BRIDGECOR STEEL BOX STERLING RANCH ROAD- CO SPRINGS COLORADO SPRINGS, CO

FOR APPROVAL

BRIDGECOR STEEL BOX
38'-1" SPAN X 11'-11" RISE
STERLING RANCH ROAD- CO SPRINGS
COLORADO SPRINGS, CO

CONTECH ENGINEERED SOLUTIONS, LLC
Design of Concrete Spread Footing Foundations,
Concrete Headwalls and Wingwalls for a BridgeCOR
Steel Box (705931); Sterling Ranch Road,
El Paso County, Colorado

SECTION

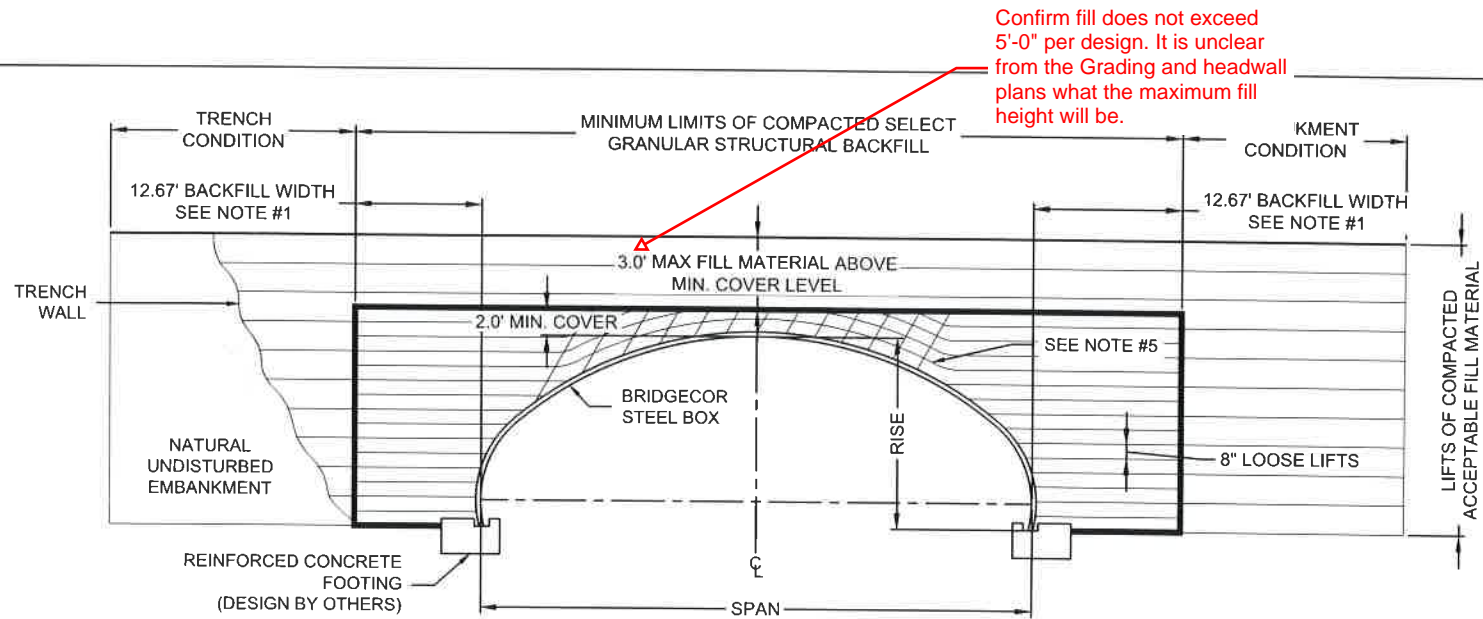
Confirm fill does not exceed 5'-0" per design. It is unclear from the Grading and headwall plans what the maximum fill height will be.
